Access Compliance Report

Public Rights-of-Way

Intersection ID: 31970	Main Street: BERNBROOKE CT	Cross Street: THORNTON OAKS CT	Location: SE
ADA ID: B3679D927EA3	Ramp Type: BlendTrans1	Initial Pass/Fail: Pass	Overall Compliance: No
		Severity Score: 15

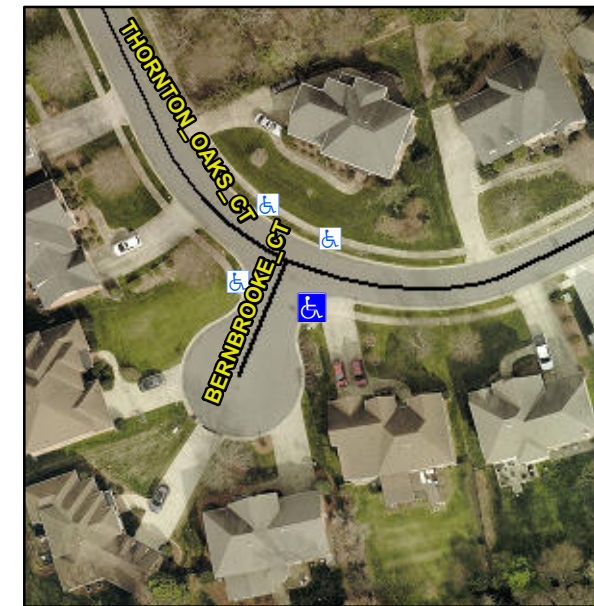
R304.2.1, R305, R304.5.4

Compliance	Description	Data	Compliance	Description	Data
N/A	Ramp Length (in)	46.0	Yes	BlendTrans Slope (%)	2.2
Yes	Ramp Width (in)	51.0	Yes	BlendTrans XSlope (%)	0.9
N/A	Flare Type LT	Sloped	N/A	Flare Type RT	Sloped
Yes	Flare Slope LT (%)	3.0	N/A	Flare Slope RT (%)	2.0
N/A	Flare Traversable LT?	Yes	N/A	Flare Traversable RT?	No
No	Landing Length (in)	46.5	No	DWS Provided?	No
Yes	Landing Width (in)	51.0	N/A	DWS Contrast?	No
Yes	Landing Slope (%)	0.5	N/A	DWS Length (in)	N/A
Yes	Landing X Slope (%)	0.3	N/A	DWS Full Width?	No
N/A	Landing Curb? (Y/N)	No	N/A	DWS Offset (in)	N/A
N/A	Shared Landing?	No			
Yes	Gutter Ponding?	No	No	Gutter Slope (%)	8.2
Yes	Gutter Lip Ht (in)	0.0	Yes	Gutter X Slope (%)	0.1
N/A	Painted X Walk1?	No	N/A	Painted X Walk2?	No
	X Walk 1 Direction	To W		X Walk 2 Direction	To N
	X Walk 1 Width (in)	N/A		X Walk 2 Width (in)	N/A
	X Walk 1 Slope (%)	2.6		X Walk 2 Slope (%)	6.2
	X Walk 1 X Slope (%)	5.6		X Walk 2 X Slope (%)	0.1

N/A	Ramp inside XWalk1?	N/A	N/A	Ramp inside XWalk2?	N/A
	Road Slope (%)	1.4		Clear Space?	Yes
	Road X Slope (%)	4.7	N/A	Clear Space to XWalk (in)	N/A
Yes	Any Obstructions?	No	Yes	Storm Grate/Utility Hazard?	No
	Obstruction Type			Storm Grate/Utility Type	
		N/A			N/A
			Yes	Surface Condition? (G/P)	Good
			Yes	Curb Slope (%)	4.4

Remove & Replace Curb Ramp With Two New Directional Ramps or Equivalent. Remove & Replace Gutter.
